BULLETIN NUMBER:
SB18-C-001E

DOOR WIND NOISE/WATER INTRUSION – IMPROVED DOOR SEAL AND ADJUSTMENT PROCEDURE

- 2011MY – 2021MY Isuzu N-Diesel
- 2011MY – 2020MY Isuzu N-Gas
- 2018MY – 2021MY Isuzu FTR

This bulletin supersedes information bulletin SB18-C-001D. This bulletin is being revised to update the Model Years. Please discard previous bulletin SB18-C-001D.

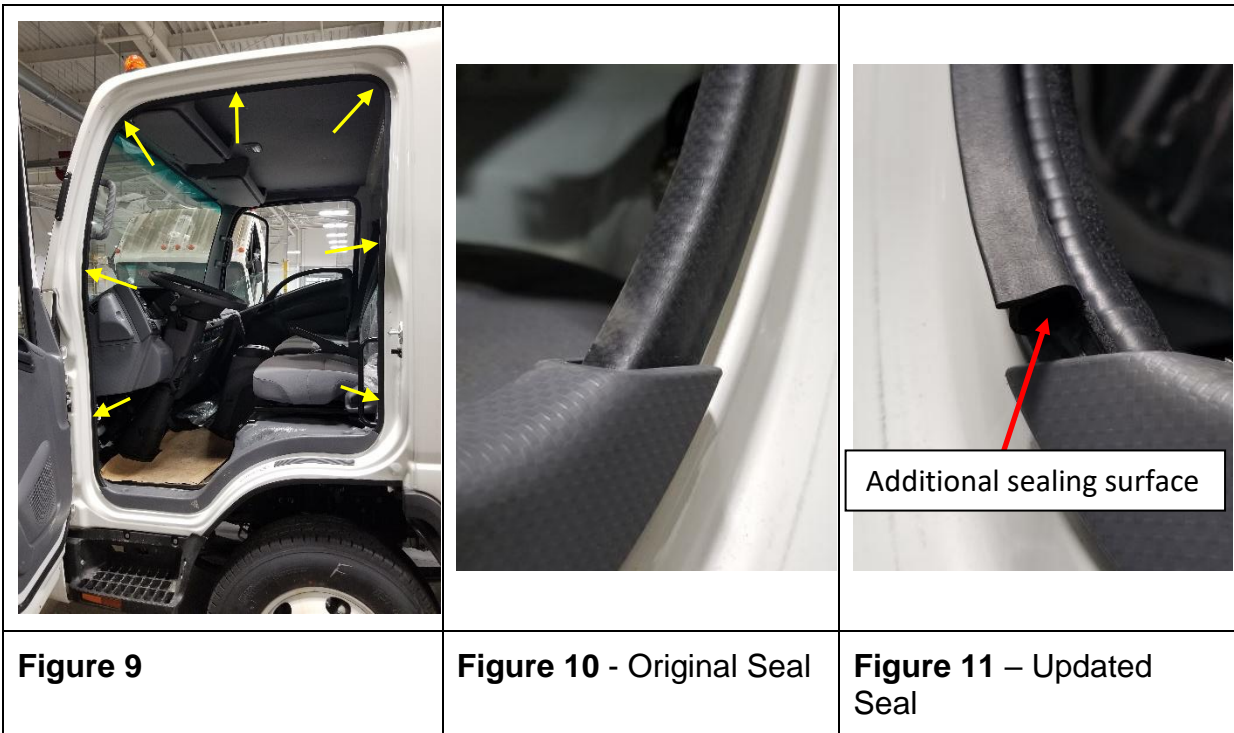
10. On single cab, N-Series vehicles check the seal on the **cab-side** of the door opening (See Figure 9) to determine if it is an original seal design or a previously offered revision. (See Figures 10 & 11.)
 - a. If the original seals are present as shown in Figure 10, replace them with the redesigned **cab seal** and continue to Step 11.
 - b. If the seals on the vehicle's **cab** are as those shown in Figure 11, skip to Step 24.
 - c. If vehicle is an FTR, continue to Step 11.

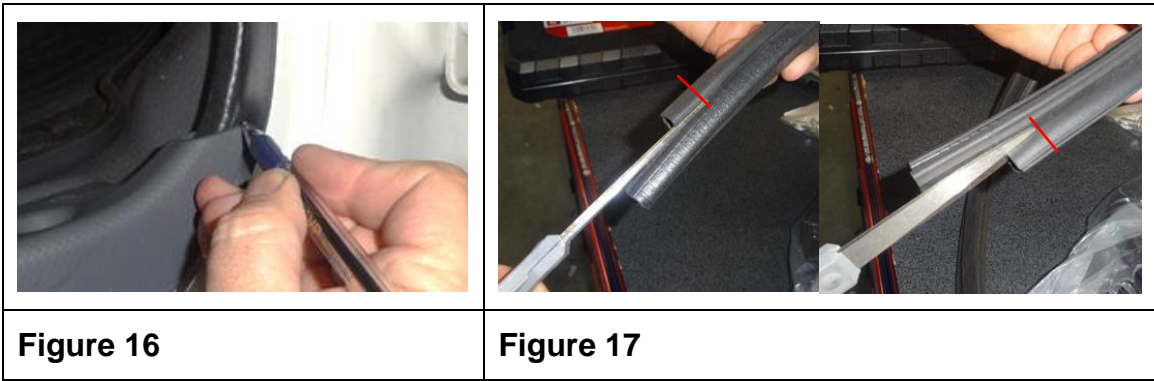
- If the new seal interferes with and sits below the door side sill protector, as shown in Figure 16 below, proceed to Step 17.
- If there is no interference, repeat on other side.
- If both doors have been completed, skip to Step 24.

17. Using a pen, mark the seal using the top of the door side sill protector as a guide to where the weather strip needs to be cut. (See Figure 16.)

Figure 20

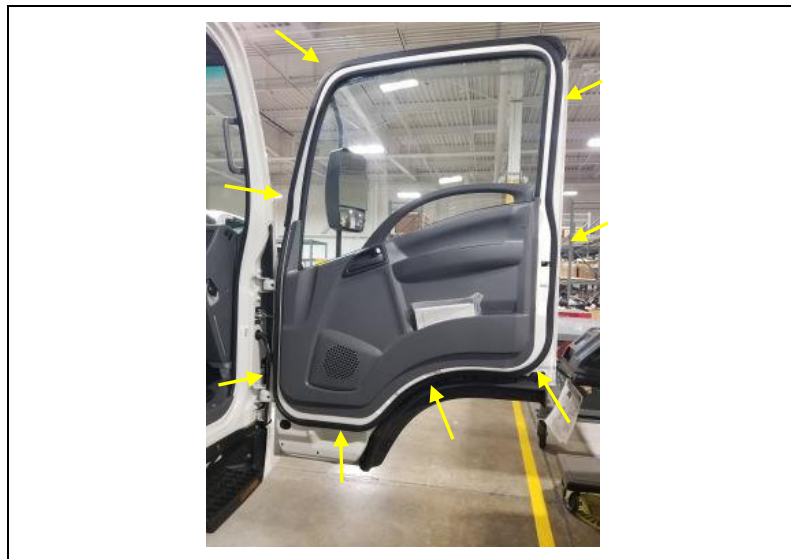
24. On single cab, N-Series vehicles check the seal on the **door side** of the door opening (See Figure 20) to determine if it is an original seal design or a previously offered revision.

- a. If the original seals are present as shown in Figure 20, continue to Step 25.
- b. If the seals on the vehicle's **door** are as those shown in Figures 21 & 22, skip to Step 29.
- c. If vehicle is an FTR, skip to Step 26.
